Access Compliance Report

Public Rights-of-Way

Intersection ID: 24164	Main Street: COMPTON_CT	Cross Street: PRESCOTT_POND_LN	Location: NE
ADA ID: 9F6DF534BDC3	Ramp Type: PerpDiag	Initial Pass/Fail: Fail	Overall Compliance: No
		Severity Score: 12.5

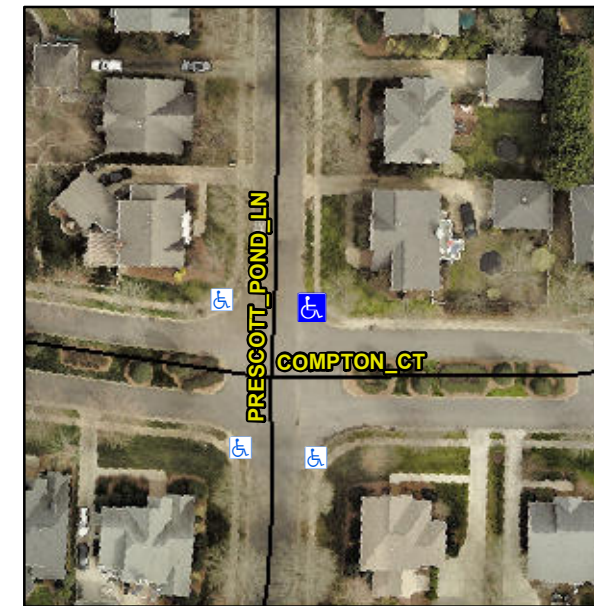
Not Found, R304.2.2

Compliance	Description	Data	Compliance	Description	Data
N/A	Ramp Length (in)	96.0	No	Ramp Slope (%)	8.4
Yes	Ramp Width (in)	48.0	Yes	Ramp XSlope (%)	0.5
N/A	Flare Type LT	N/A	N/A	Flare Type RT	N/A
N/A	Flare Slope LT (%)	N/A	N/A	Flare Slope RT (%)	N/A
N/A	Flare Traversable LT?	N/A	N/A	Flare Traversable RT?	N/A
N/A	Landing Length (in)	N/A	N/A	DWS Provided?	N/A
N/A	Landing Width (in)	N/A	N/A	DWS Contrast?	N/A
N/A	Landing Slope (%)	N/A	N/A	DWS Length (in)	N/A
N/A	Landing X Slope (%)	N/A	N/A	DWS Full Width?	N/A
N/A	Landing Curb? (Y/N)	N/A	N/A	DWS Offset (in)	N/A
N/A	Shared Landing?	N/A			
N/A	Gutter Ponding?	N/A	N/A	Gutter Slope (%)	N/A
N/A	Gutter Lip Ht (in)	N/A	N/A	Gutter X Slope (%)	N/A
N/A	Painted X Walk1?	No	N/A	Painted X Walk2?	No
	X Walk 1 Direction	To S		X Walk 2 Direction	To W
N/A	X Walk 1 Width (in)	N/A	N/A	X Walk 2 Width (in)	N/A
	X Walk 1 Slope (%)	3.5		X Walk 2 Slope (%)	0.4
	X Walk 1 X Slope (%)	0.5		X Walk 2 X Slope (%)	3.4

Remove & Replace Curb Ramp With Two New Directional Ramps or Equivalent.
